ENVIRONMENTAL VARIANCE REQUEST REVIEW SHEET

CASE: SP-2010-0004C(R1)

PROJECT NAME: ABIA Remain Overnight Apron Expansion

SUBJECT: ABIA Remain Overnight Apron Phase 1 –
SP-2010-0004C(R1)

DEPTHS OF FILL

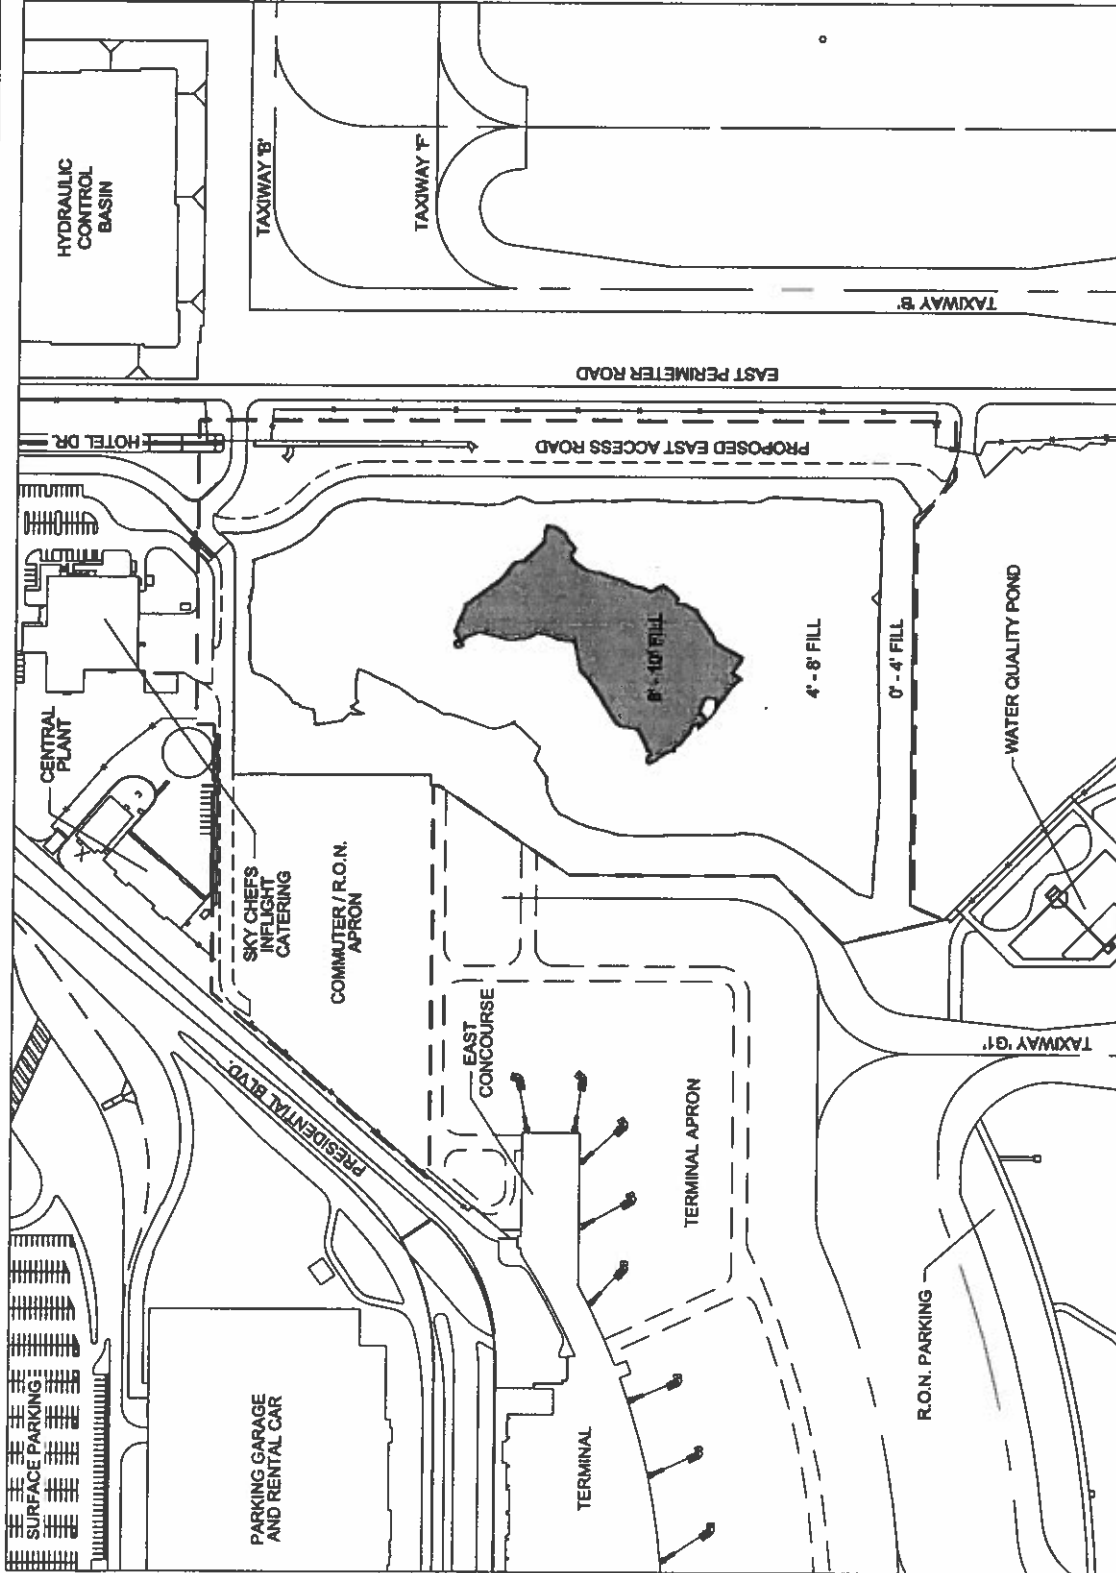
1. The applicant is requesting approval of an environmental variance from LDC 25-8-342 – to allow fill up to 10 feet in order to accommodate expansion of the existing Terminal Apron pavements for Remain Overnight aircraft use.

There will be significant change in existing slope in order to construct the embankment of the aircraft apron. A depth of 4-10 feet of fill will be placed over approximately 19 acres (~35,000 cubic yards). The size of the existing borrow stockpile will be reduced more than half in order to construct the embankment. No CEF's are present on site. There are no slopes on site greater than 15%.

This request is part of a Site Plan Revision Application for the City of Austin's Remain Over Night (RON) Apron-Phase 1-Rebid project at Austin-Bergstrom International Airport (ABIA). This project is located within the Onion Creek Watershed (suburban watershed). The proposed project includes construction of a soil embankment (fill) with a surface area approximately 87,100 square yards in size. This embankment is to be built to accommodate expansion of the existing Terminal Apron pavements for RON aircraft use, in a subsequent, separate project. Since the pavement gradients for the apron expansion must be designed to meet Federal Aviation Administration (FAA) design standards as stipulated in FAA Advisory Circular (AC) 150/5300-13, *Airport Design*, the proposed fill for this pavement will generally exceed four (4) feet in depth, with some locations exceeding eight (8) feet in depth, measured from the surveyed existing ground. The maximum depth of fill will be approximately ten (10) feet.

1. There are special circumstances applicable to the property involved. The pavement gradients for the anticipated apron expansion must be designed to meet FAA design standards as stipulated in FAA Advisory Circular (AC) 150/5300-13, *Airport Design*, for safe operation of aircraft. As a result, the required fill construction for this pavement will generally exceed four (4) feet in depth, with some locations exceeding eight (8) feet in depth, measured from the surveyed existing ground. The maximum depth of fill will be approximately ten (10) feet.

Staff recommends approval of this variance without conditions. The findings of fact have been met (see attached).

The findings of fact have been met. Staff recommends consent approval of this variance without conditions.
